EXHAUST SILENCERS

TECHNICAL COMMUNICATION No. 02-2003

TECHNICAL ANNOUNCEMENT NO. 10 - 2003

TECHNICAL ANNOUNCEMENT No. 11-2003

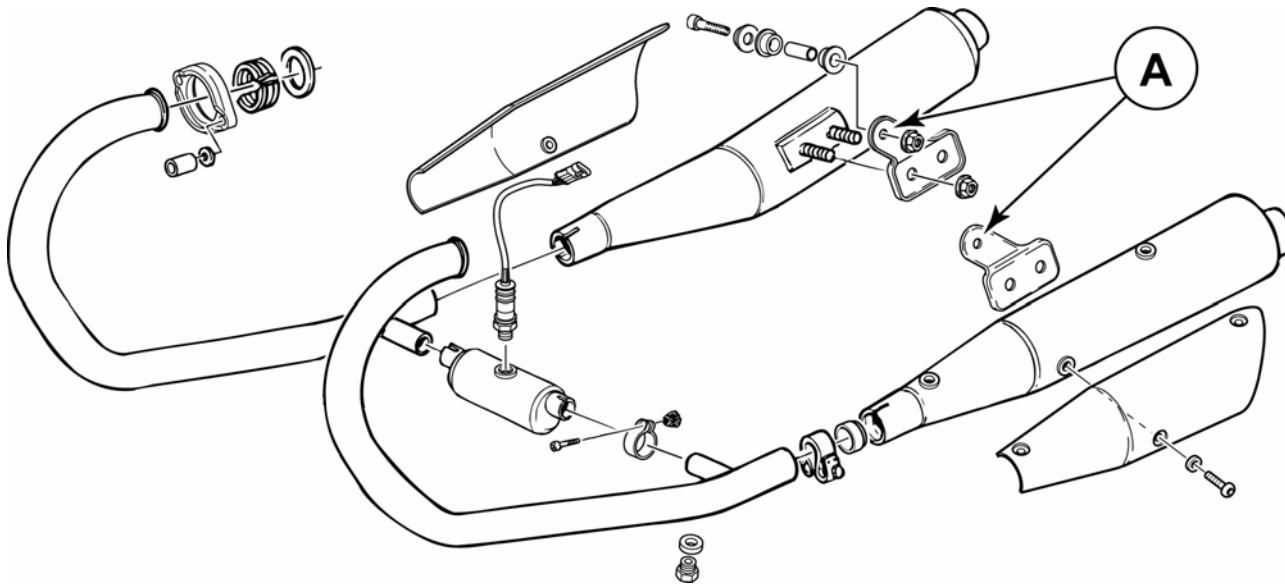
The exhaust silencers come off due to the inadequate length of the exhaust pipes.

For the new bikes, the exhaust pipe length has been changed.

For the bikes already manufactured, the problem can be solved by cutting slots on the silencer brackets (A).

Subject: oil in the air box

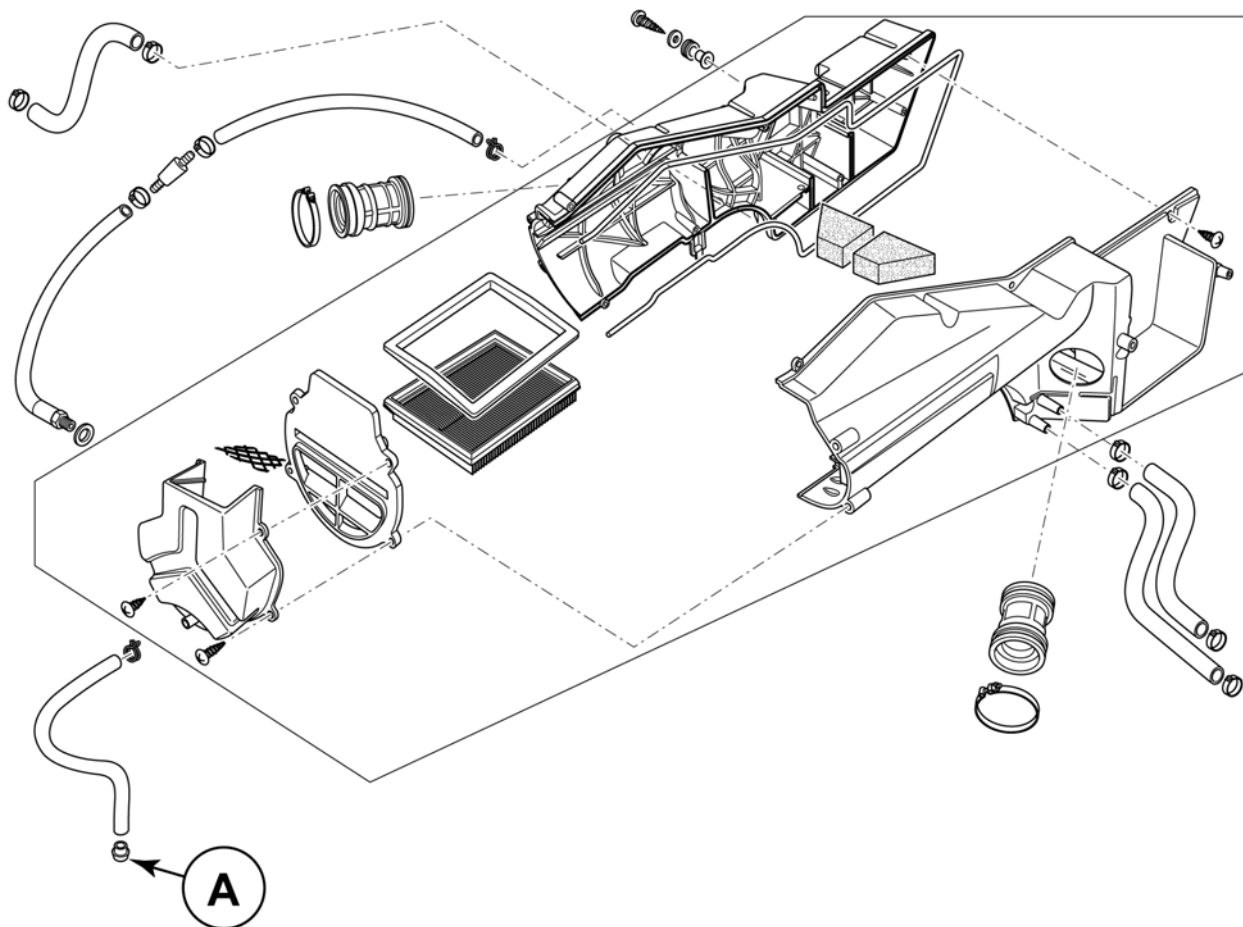
oil entering in the air box stays in the box bottom and goes out of the joints or the plug (A) fitted at the drain pipe end.

before fitting the air box to the vehicle, we check the air box sealing carrying out a leak test with air under pressure.

The plug (A) has been changed with a watertight plug.

Subject: engine oil level

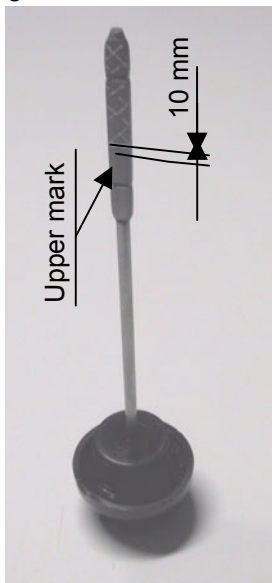
Fault experienced on vehicle: excessive quantity of oil extracted from the oil recover circuit.

Main cause: excessive quantity of engine oil.

Technical solution: check and restore correct engine oil quantity (1.8 kg).

The checking operation can be easily carried out by using the oil filler cap dipstick. The correct quantity of oil wets the dipstick up to around 10-11 mm under the maximum level reference mark. The highlighted part in the photo shows the section of dipstick which must be wet. The check must be carried out with the engine warmed up, after around 20 minutes that it is running.

Subject: Throttle position data missing

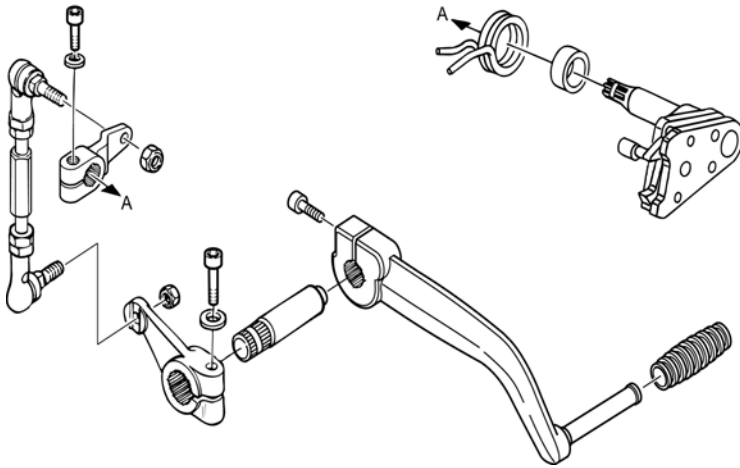
the engine does not work correctly and tends to stop. The parameter "**Correct throttle pos**" read with Axone indicates **2.3 °** (normally, it should read between **2.7°** and **3.5°**).

reset the throttle with Axone.

Adjust the cylinder synchronization and idle speed.

Subject: jamming of gearchange preselector

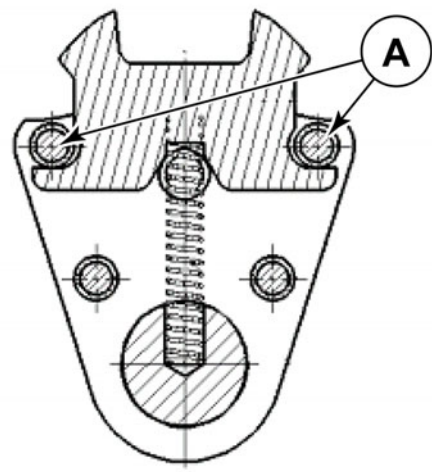
the slide inside the preselector might jam when in contact with the two pins (A).

the diameter of the pins was increased (from 7.0 mm to 7.2 mm), and the concentricity tolerance was decreased.

Subject: Gearchange clutch dogs

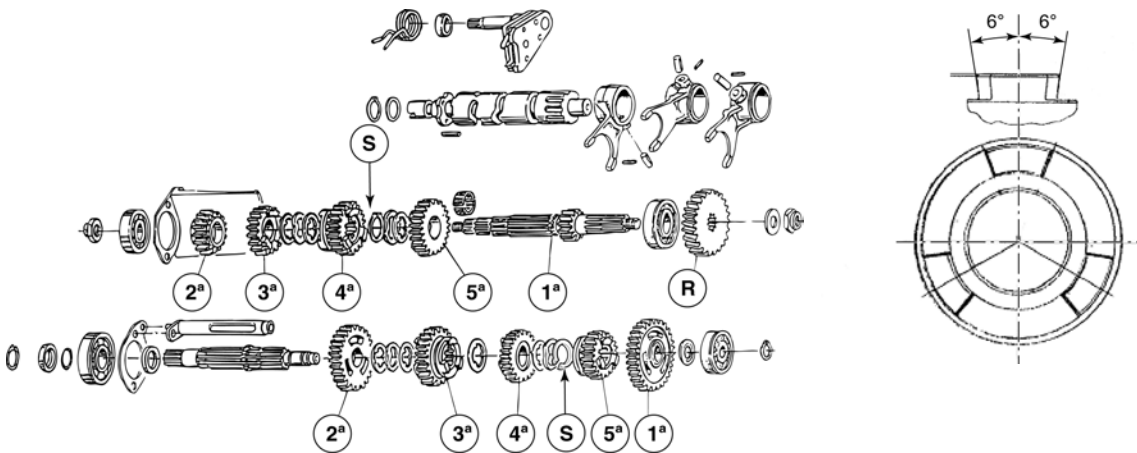
the **3rd** and **4th** gears slip out.
We highlighted two causes:

1. The circlips (**S**) doesn't keep the washer in place.
2. After inspecting the **3rd** and **4th** gears clutch dogs, it was noticed that the angle was not correct (should be **6°**) maybe due to wrong machining or because it was exchanged with one for the Brevia 750 gearchange.

1. it was fitted the circlip for the Brevia gearchange (**inner diameter undersized by 0.5 mm part no. 90271124**).
2. Changing the gears that do not comply with the drawings.

Subject: oil in the air box

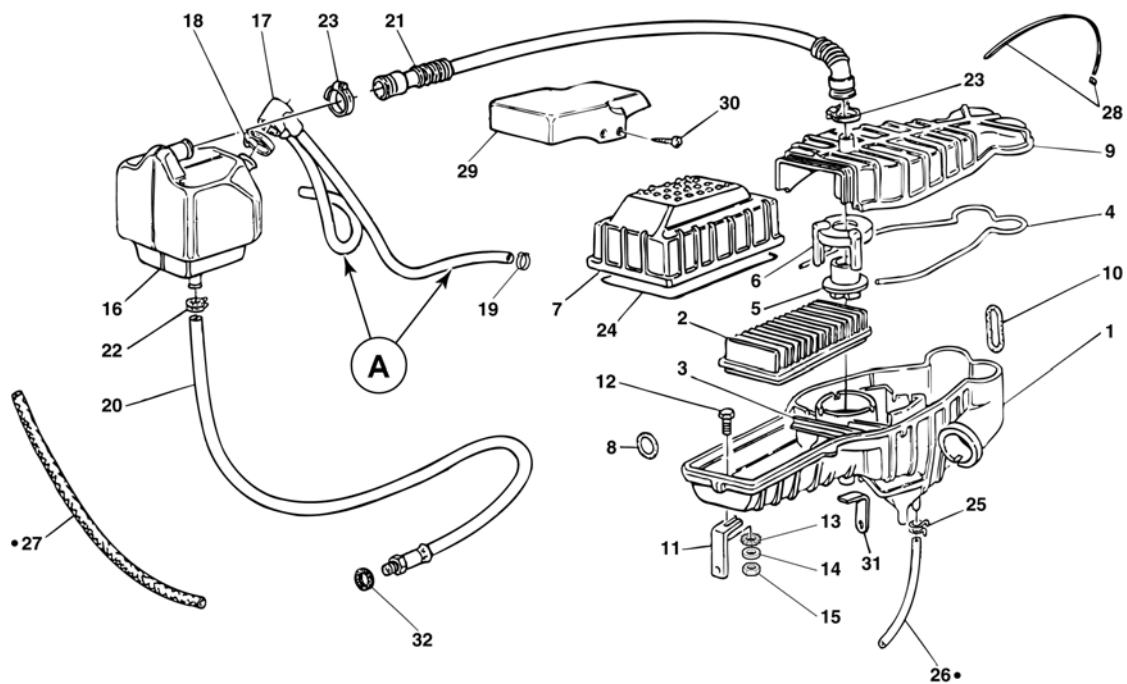
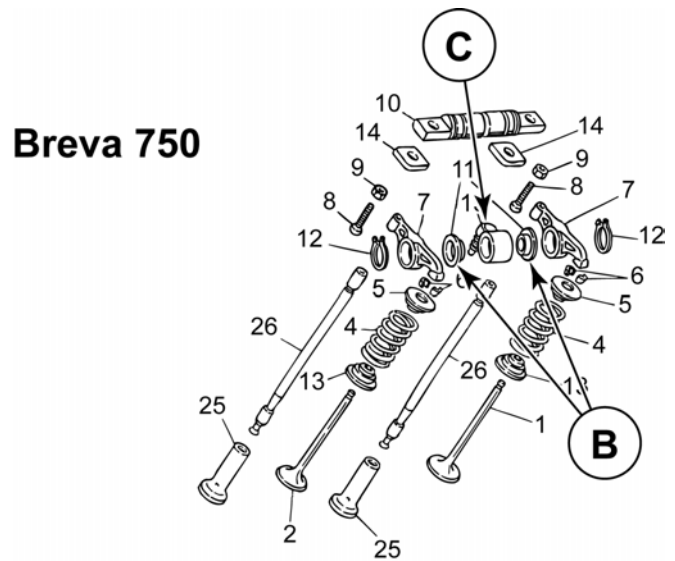
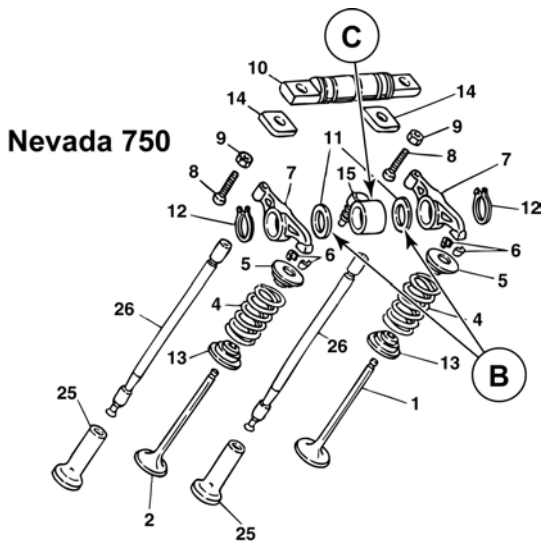
too much oil in the air box

The presence of oil in the decanter box and -following oil vapours circuit- in the air box has two main causes:

- too high oil level
- high pressure of the gases inside the crankcase

- Check that the two hoses (A) taking the oil vapours from the head covers to the decanter are not squashed due to their flexibility; if so, change them with more rigid hoses.

- Change the hose (C) and the shims (B) with the ones for the Brevia 750 model (for vehicles manufactured before 2003).

- Should the problem persist, change the piston rings.
- Should it be necessary to change the pistons, it is recommended to change them with the ones for Brevia model.

Subject: engine oil level

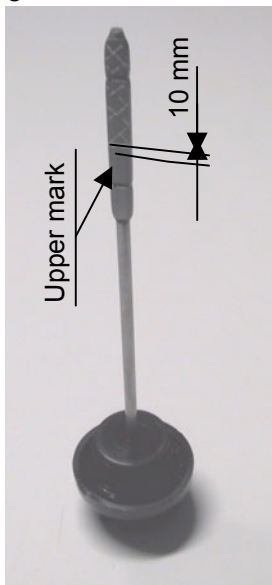
Fault experienced on vehicle: excessive quantity of oil extracted from the oil recover circuit.

Main cause: excessive quantity of engine oil.

Technical solution: check and restore correct engine oil quantity (1.8 kg).

The checking operation can be easily carried out by using the oil filler cap dipstick. The correct quantity of oil wets the dipstick up to around 10-11 mm under the maximum level reference mark. The highlighted part in the photo shows the section of dipstick which must be wet. The check must be carried out with the engine warmed up, after around 20 minutes that it is running.

Subject: carburetion

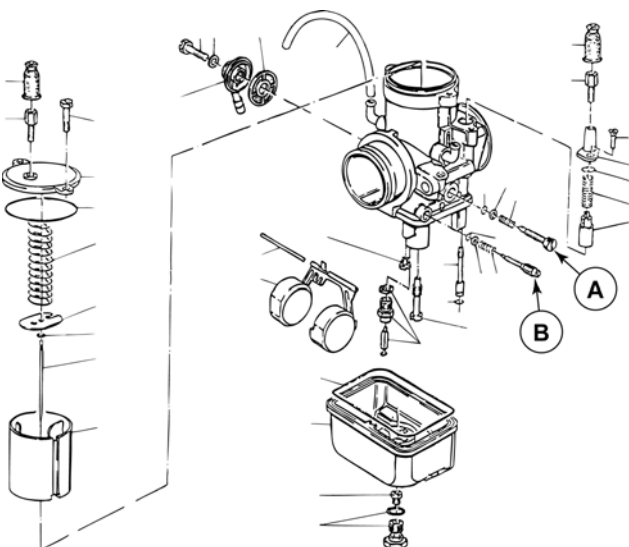
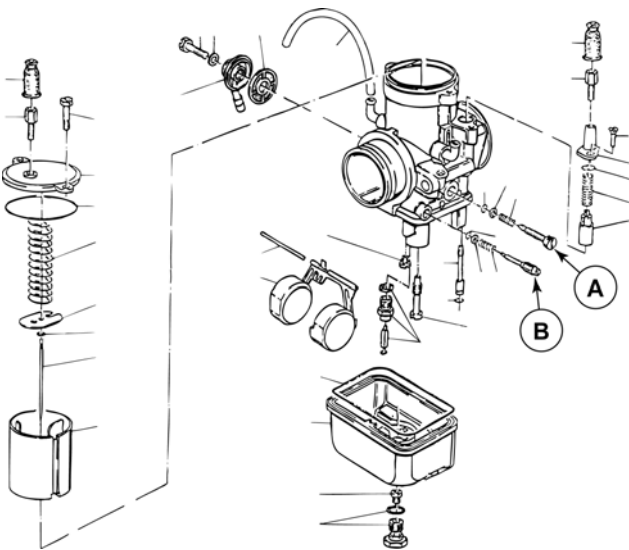
- Backfiring when releasing the throttle
- Erratic idling after acceleration
- Air leakage in the air box

Use the mixture adjusters (**B**) to adjust the carburetion.

Check the valve sealing using the SUN-TEST (BOSCH), put the combustion chamber under a pressure of 5 bars.

If the test result is negative, it is necessary to grind the valve seat.

Object: control unit identification

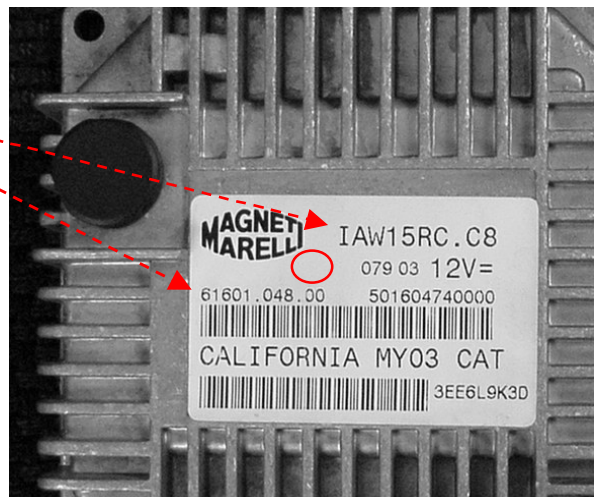
Defect found on vehicle: engine's irregular delivery

Possible cause: wrong gauging of the electronic control unit

Technical solution: control unit's replacement

Should the control unit assembled on the vehicle be incorrect, replacing it is indispensable.

Subject: new battery

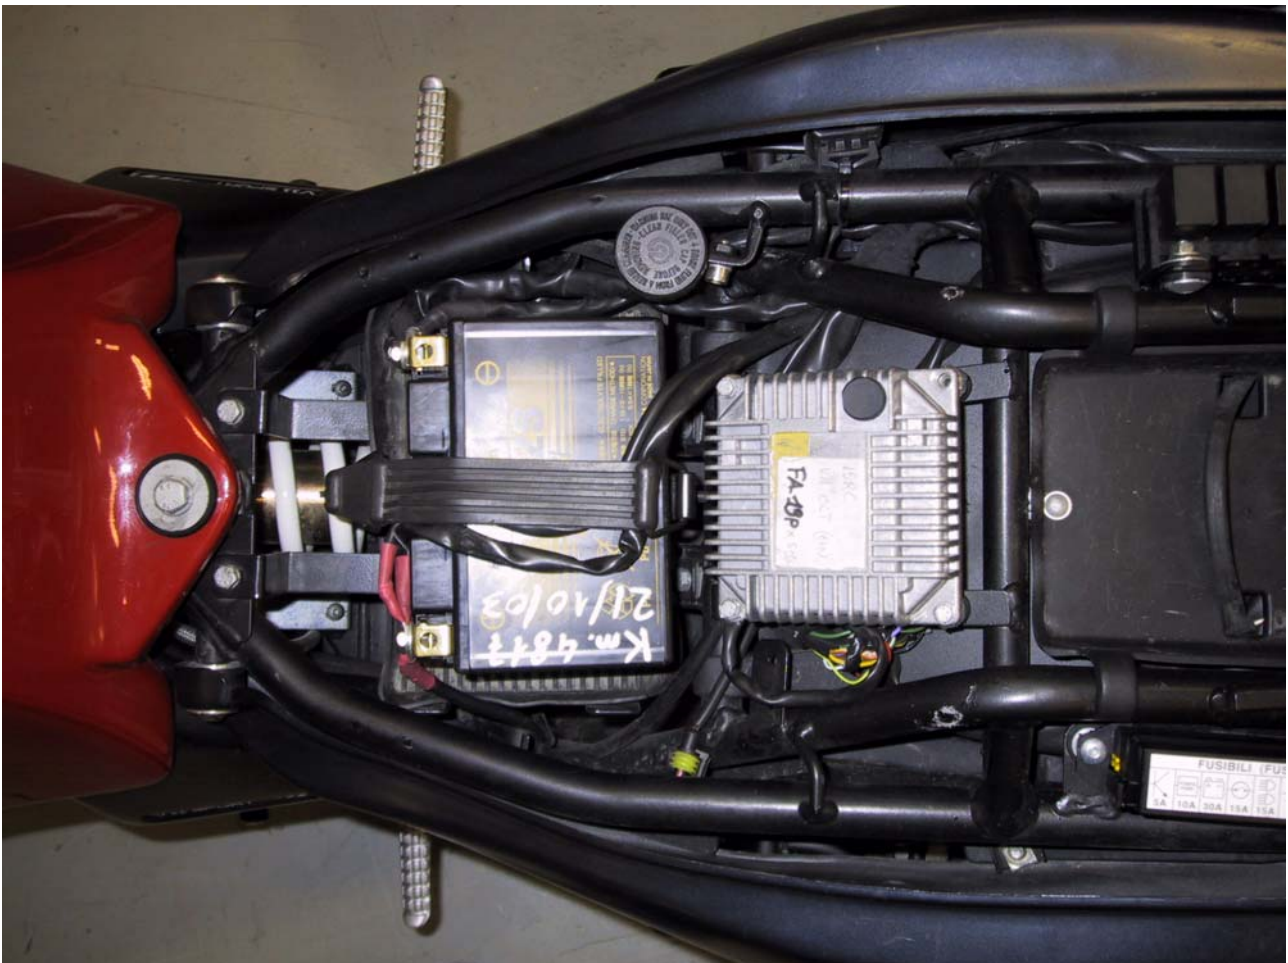
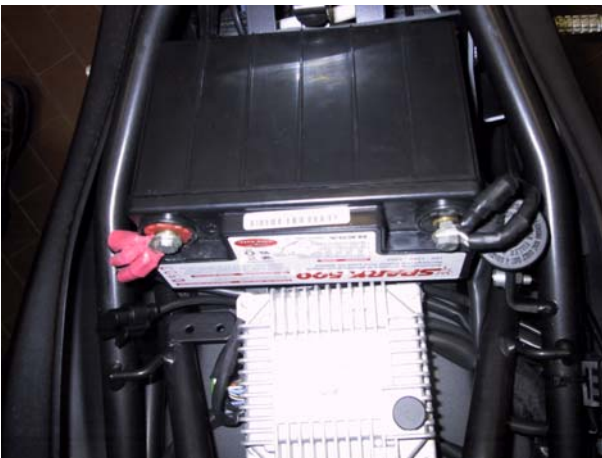
short life-span of the presently fitted **ESA SPARK 500E** battery.

the **YUASA YTZ12S** battery will be fitted (comes from Yuasa already filled with fluid).

In production is fitted a new wiring while on bikes with present wiring it is possible to fit the battery and re-route the cables.
